DEXIN Corporation, Ltd

Model: S3C

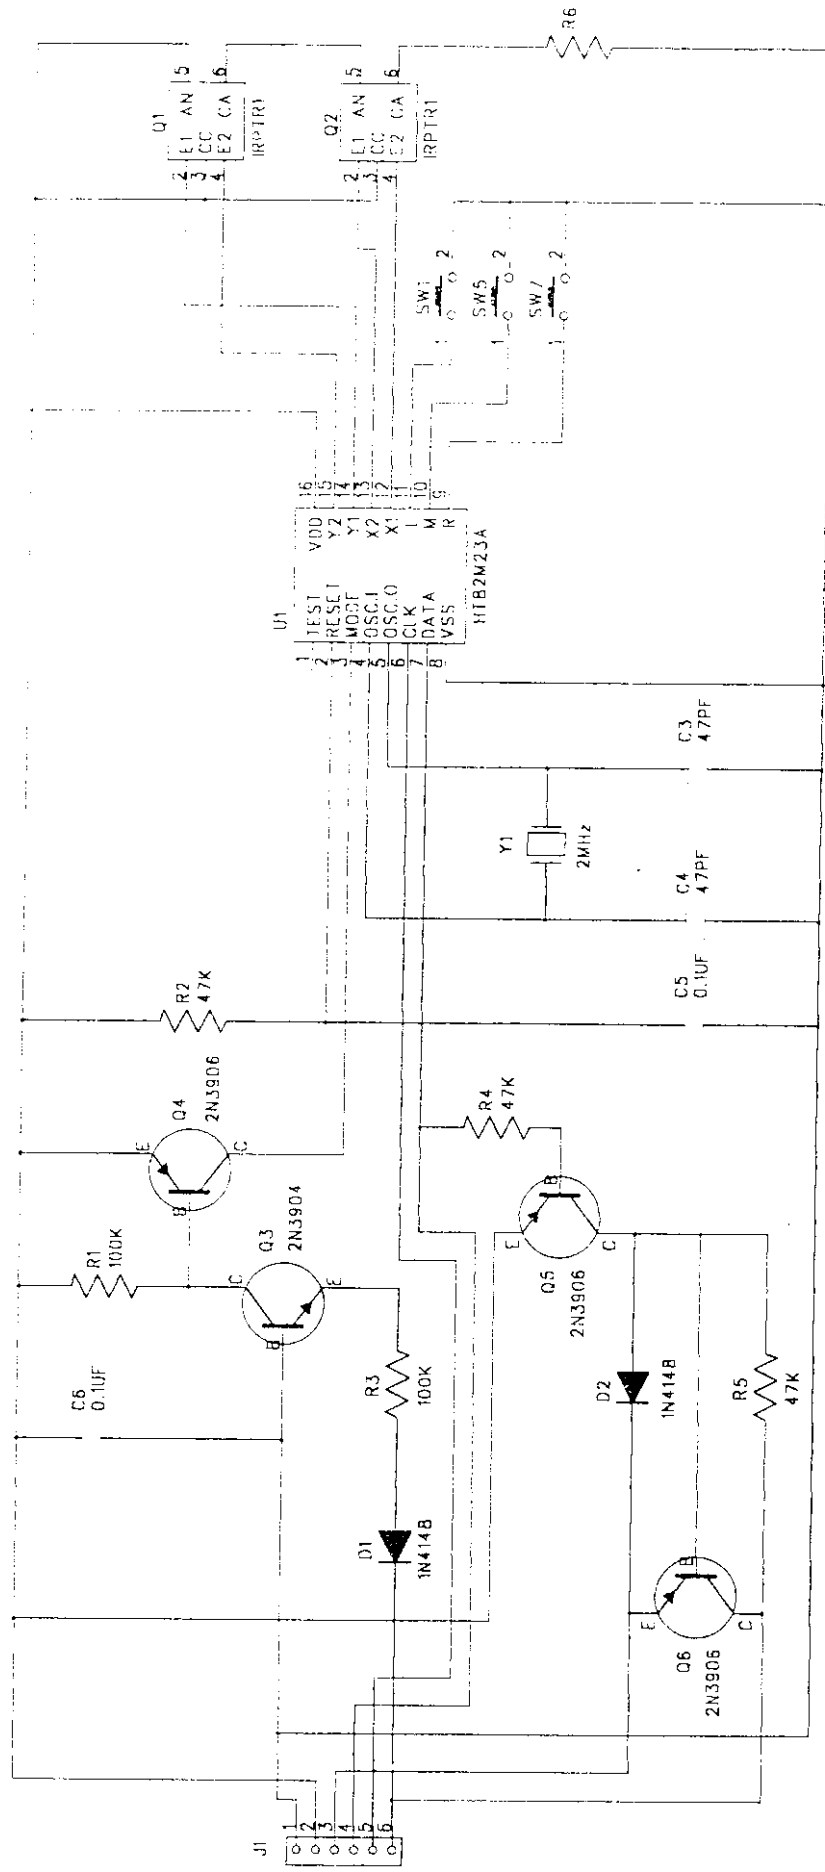
Note:
 For backward compatibility to the prior FCC and CE passed PCB,
 R2 is retained but will not be installed.
 Z01 is retained for the same reason as R2 is.
 R1 has been replaced by D2.
 ***The previous controller for serial mouse was HT6515,
 but is switched to HM8375, or HMR370 (next alternative).
